**Pacific Gas and
Electric Company®**

October 15, 2007

PG&E Letter DCL-07-097
U.S. Nuclear Regulatory Commission
ATTN: Document Control Desk
Washington, D.C. 20555-0001

License Amendment Request 07-04

Figure 1. Surveillance Frequency Control Program Change Process

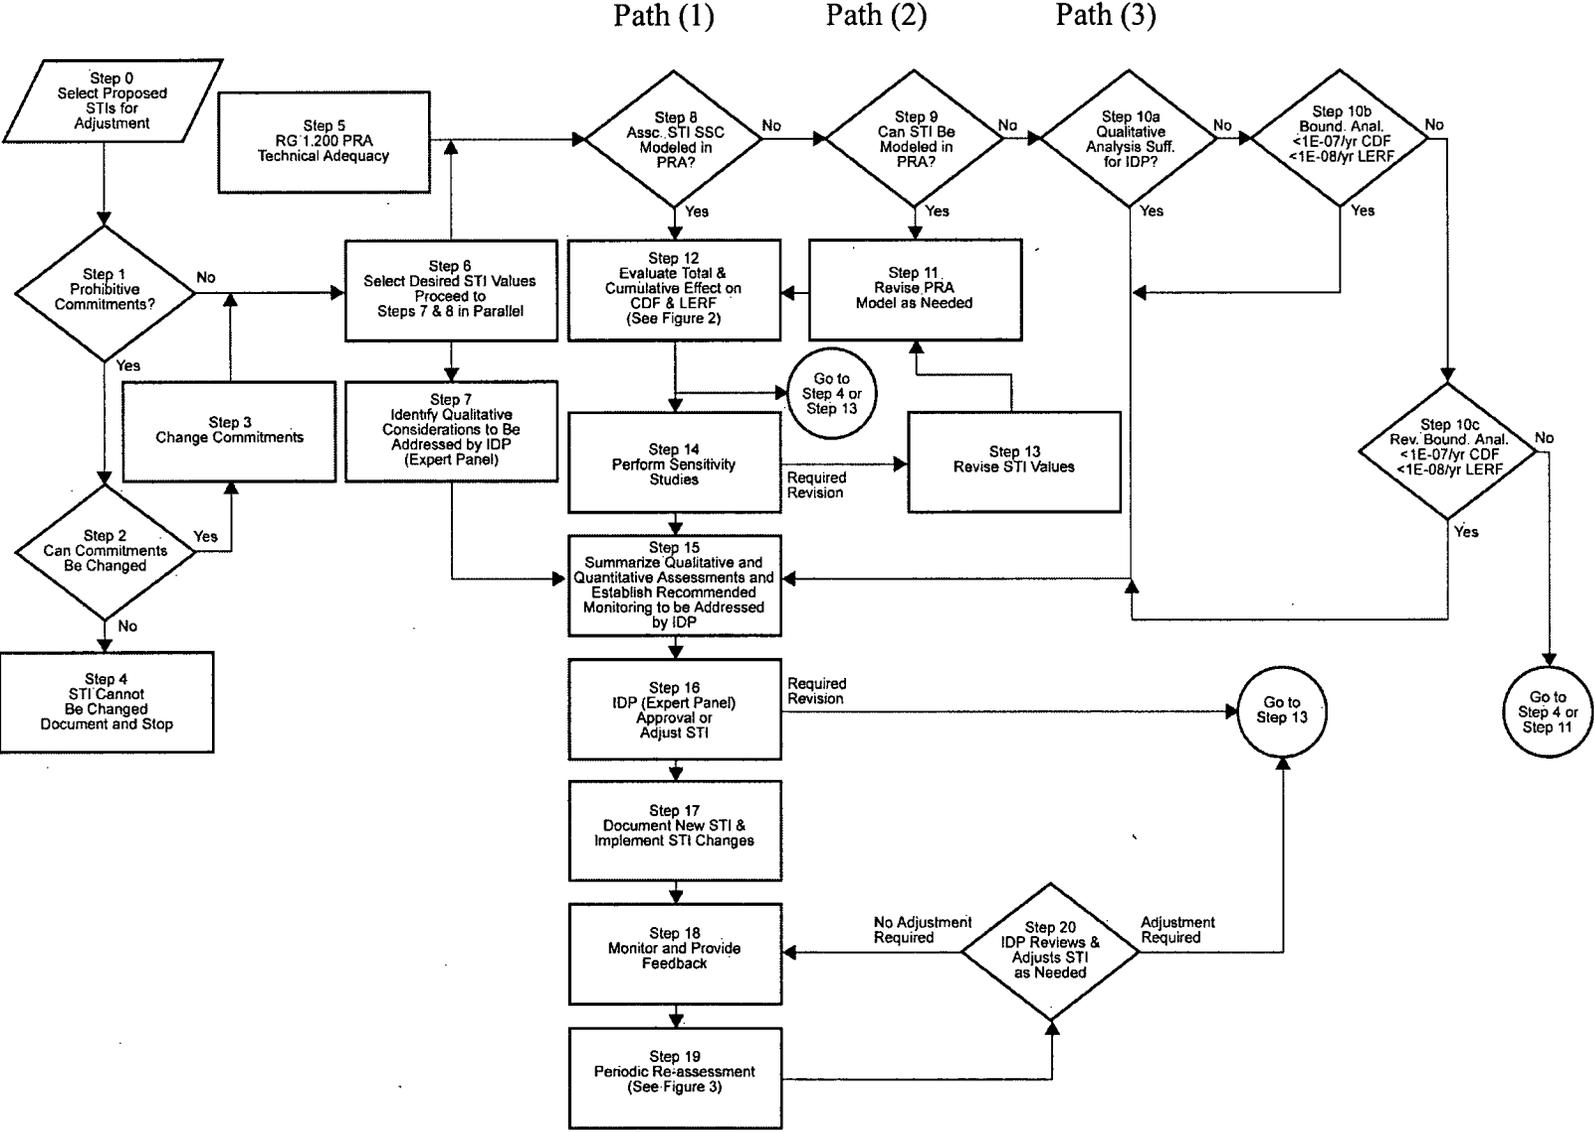
Figure 1 in NEI 04-10 provides a process flow map for the SFCP. The process includes three different branches to follow depending on how PRA is modeled, as shown in Figure 1 below in steps 8, 9, and 10:

Three process paths are identified on the marked up figure below as Path (1), Path (2), and Path (3).
